Information Request DTE-7-1

**NSTAR Electric
Standby Rate Design**

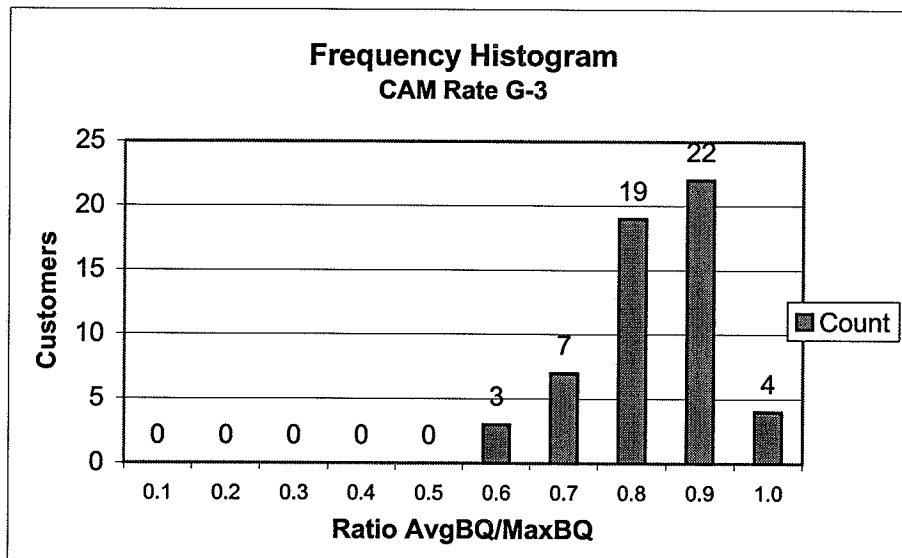
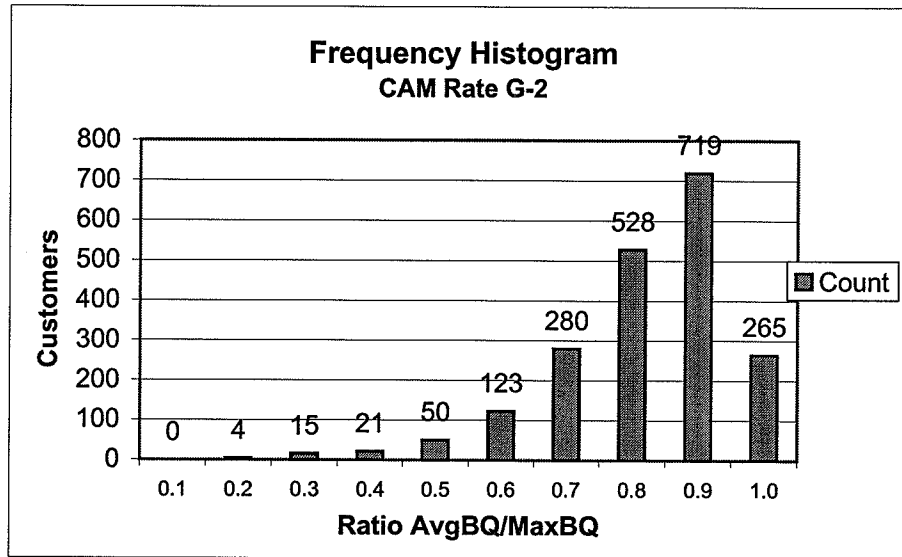
Please reconcile the apparent inconsistency between the use of "Average/Max billing demand ratio" in Exhibit NSTAR-HCL-7, at 14-15 compared with the "MaxBQ/AvgBQ" ratios shown in Exhibit NSTAR-HCL-8.

The labels describing the information presented on the exhibit are incorrect. The labels should read "AvgBQ/MaxBQ". See Transcript 1, page 18.
